Jeff apple Benowitz
PhD Geology
PO Box 753851
Fairbanks, Alaska
99775

Manh Choh ore extraction site DNR/DEC permit comment
(manh.choh.comments@alaska.gov)

Draft Waste Management Permit 2023DB0001
And
Draft Reclamation Plan Approval (F20232626RPA)

Figure 1: From Bemis, S.P., Weldon, R.J. and Carver, G.A., 2015. USGS Earthquake catalog: 2000 to 2013 to 30 kms depth and > M2. Red square general extraction area.

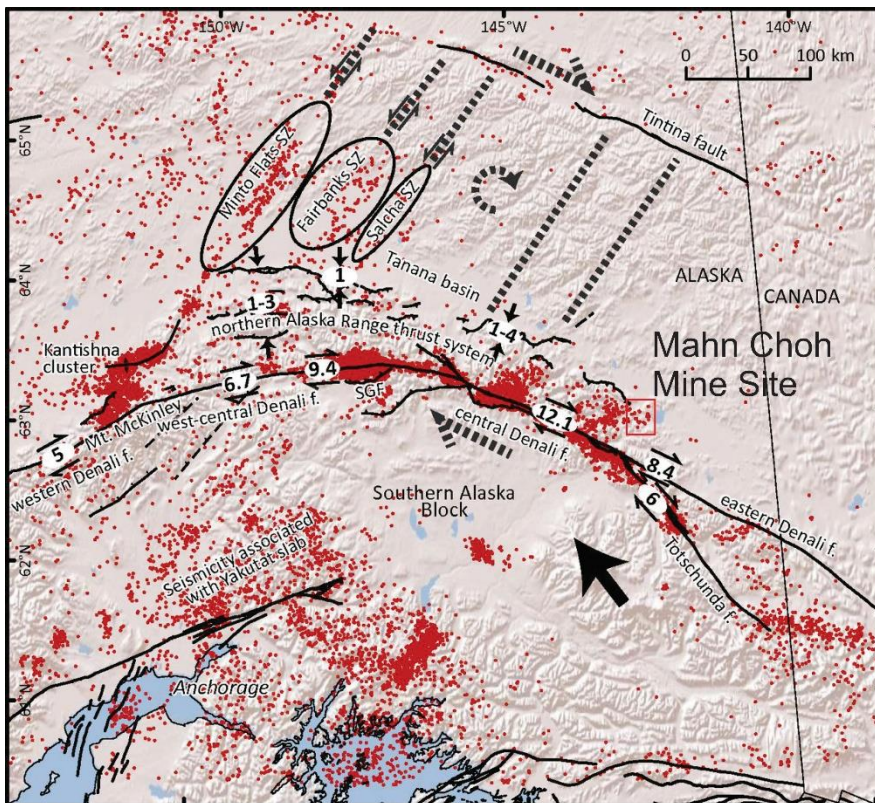
In my review I could find no mention of earthquake/seismic hazards-considerations in any of Manh Choh **extraction** site permit/plan documents. The Manh Choh **extraction** site is ~40 kms from the Denali Fault, one of the most seismically active faults in the world which ruptured in 2002 with M7.9. (Eberhart-Phillips et al., 2003). The devastating Turkey quake for comparison was a M7.8.

The active Cathedral Rapids fault (Carver et al., 2010; Koehler et al., 2012; Bemis et al., 2012; 2015), a low-angle thrust, is ~15 kms to the north west of the Manh Choh extraction site and part of the Northern Alaska Range Fold and Thrust Belt seismic region which can generate M6 earthquake events (Doser et al., 2023). Doser et al. (2023) stated

Not only is the Manh Choh extraction site located between two active major structures, but the region itself is dissected by faults (Fig. 1) (Avalon et al., 2013; Illig, 2015). Plotted earthquakes from the USGS earthquake catalog from 2000 to 2013 to 30 kms depth and > M2 demonstrate the mine site itself can experience seismic events (Fig. 2). How will the covering on the north pit respond to seismic events? Will the planned lake in the south pit drain during a seismic event?

8) Kinross-Contango Ore-Peak Gold LLC should be required to do a seismic hazard assessment for the Manh Choh ore extraction site and how it may or may not affect their waste management/reclamation plans before being awarded a DNR/DEC permit/accepted plan. The extraction site is located between active the Cathedral Rapids and Denali faults and the extraction-waste storage site has many documented faults-some likely seismically active based on the large number of earthquake epicenter located on the extraction property.
